# MORGAN OFFSHORE WIND PROJECT: GENERATION ASSETS

## Annex 4.1 Applicant's response to Ørsted's IPs submission at Deadline 4

Document Number: MRCNS-J3303-RPS-10236

Document Reference: S\_D5\_4.1

Figure 1.1: Hornsea Project One and Hornsea Project Two as-built wind turbine layouts.

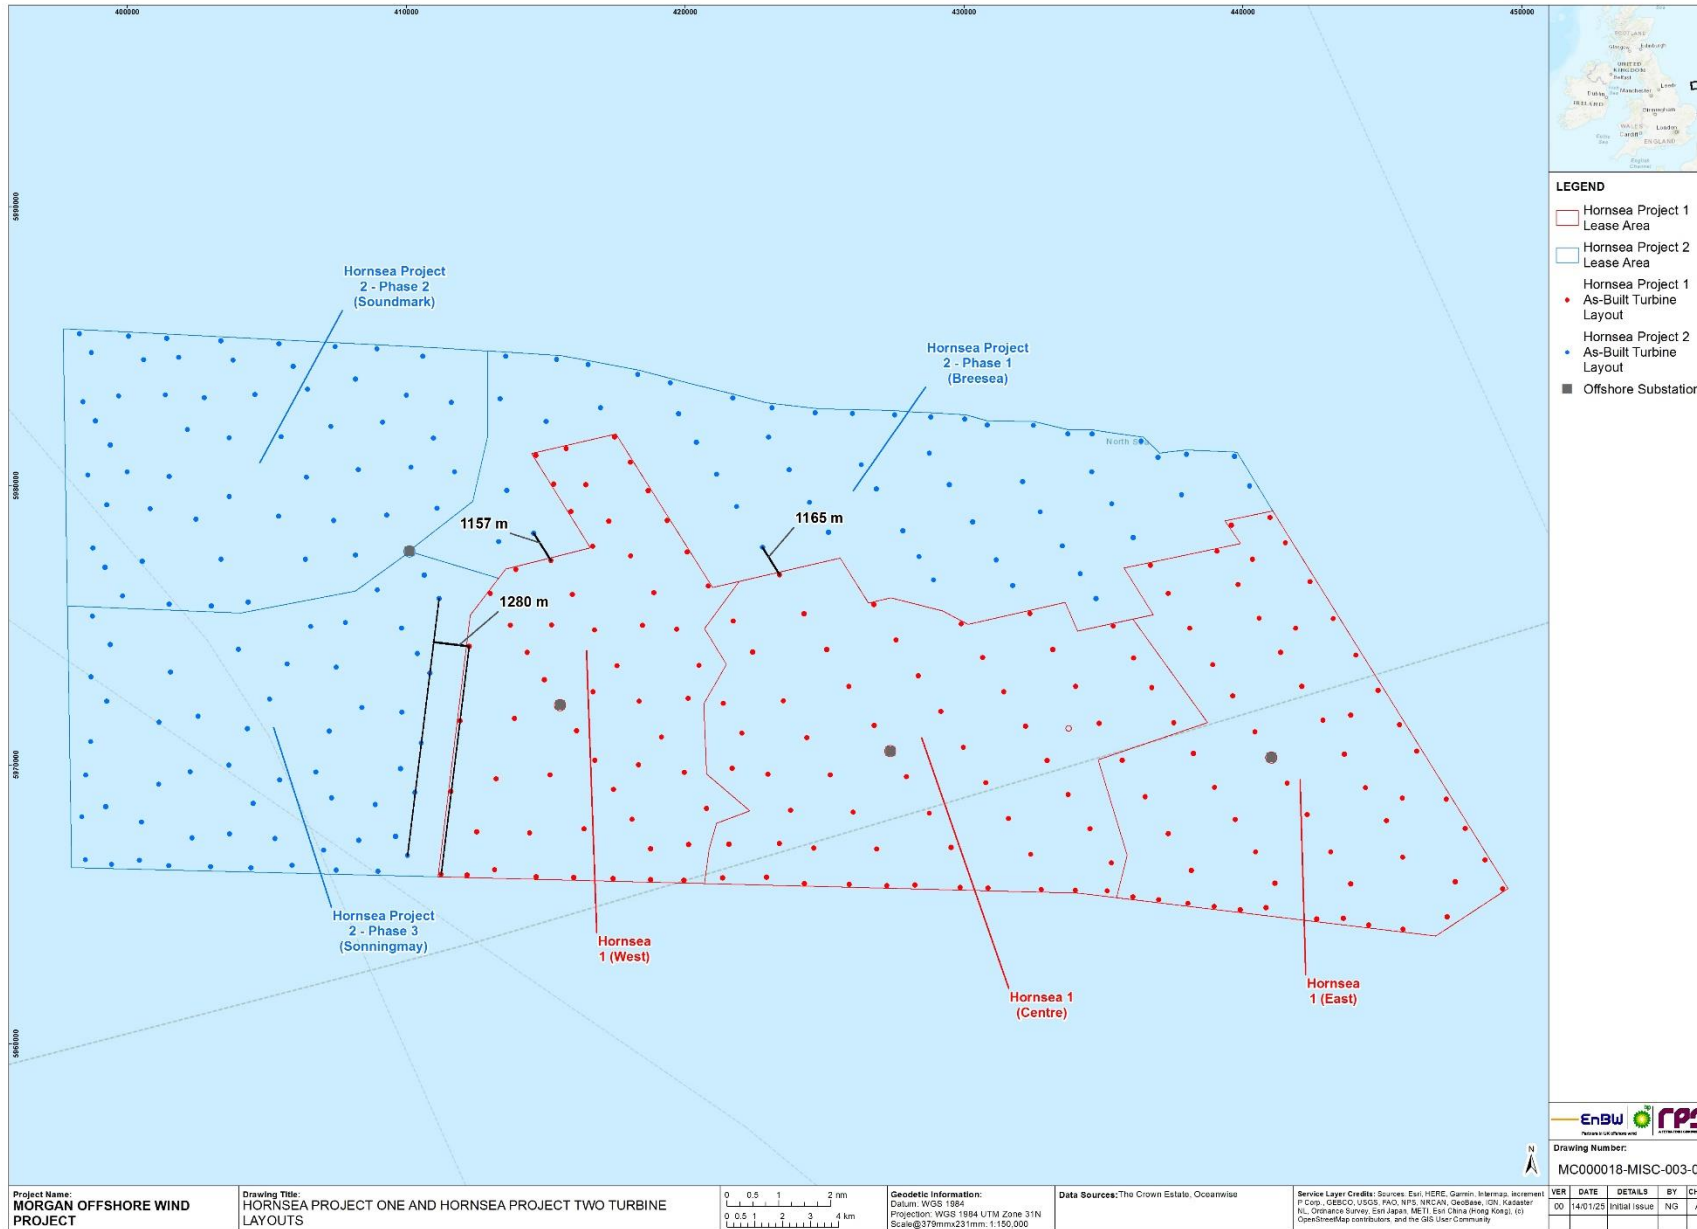
*3.12 The Applicant's understanding is that prior to Awel y Mor, wake effects have not been considered within consenting applications for proposed offshore wind developments. This understanding is not correct. The Ørsted IPs are aware that wake effects were openly considered during the consenting process for the Burbo Bank Extension offshore wind farm, the Walney Extension offshore wind farm, and the Hornsea 2 offshore windfarm.*

The Applicant highlights, based on as-built data publicly available from Oceanwise, that the distances between the as-built wind turbines of Hornsea Project Two and Hornsea Project One at the boundary are within the ranges seen for 'within project' separation distances (i.e. there is no buffer apparent between Hornsea Project One and Hornsea Project Two), with the closest distances at 1,280 m (western boundary), 1,157 m (northwestern boundary) and 1,165 m (northern boundary) (see Figure 1.1). This is significantly closer than the closest separation distance between the Morgan Generation Assets and the nearest Ørsted IPs project (8.1 km at its closest point). It is therefore assumed that the distances proposed by Hornsea Two were sufficient to resolve the concerns raised by the Project One Companies regarding wake losses, energy production and long term business case for the project, based on a far greater percentage impact than that being put forward by the Ørsted IPs for the Morgan Generation Assets.
